# ENGINEERING CHANGE NOTICE

<b>DART AEROSPACE LTD</b>		Amendment Design Review (ADR) Yes/No:	<input checked="" type="checkbox"/>	ECN #:	<b>962</b>
Date:	07.05.08	ADR Date:	07.05.08		
Job No:	00069	Created By:	RLL	Checked By:	
Product No:	D206-642	Approved By:		Approved By:	
Product Name:	SKIDTUBE INSTALLATIONS	(Proj. Manager)	H	(Management if reqd)	N/A

MDL-D206-642 REV R, D3535 REV B, D3537 REV C

file-work of 03535-X wearshoe only

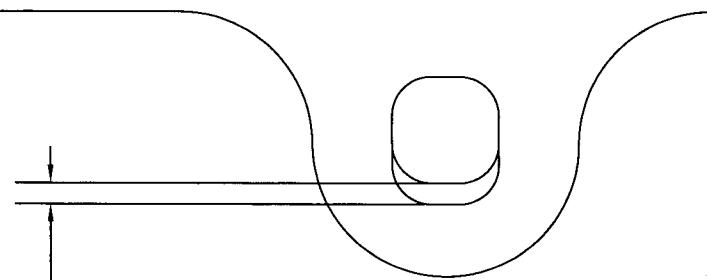
- RE-WORK D3535 IN STOCK IN ACCORDANCE WITH ATTACHED SCHEME
- RE-WORK D3537 WELDING DETAIL ONLY, NOTE: \*\*\*USE WITH D412-742 FLOAT SKIDTUBES ONLY\*\*\*
- DRAWING D3537 REV C RELEASED BY PH BASED ON ATTACHED E-MAIL FROM D. SHEPHERD

We are trying to ship a 206L/407 float skidtube with stainless steel wearplates and the rubber gasket. Upon assembly we have found that the extra thickness the gasket gives, causes a difficult fit for the wearplate.

Jason opened the holes on the tab and the bolts not fit properly, to join the wearplates to the skidtube (see the attached pictures). We would have to open up all the wearplate tabs.

Is this an acceptable deviation for this shipment?

For future shipments the flat pattern will need to be updated.

This is an acceptable deviation to me.

However, the parts have to be cleaned up considerably from what I saw in the pictures (deburred and paint touched up).

- 1) REMOVE 0.060
- 2) DEBURR AND TOUCH UP PAINT
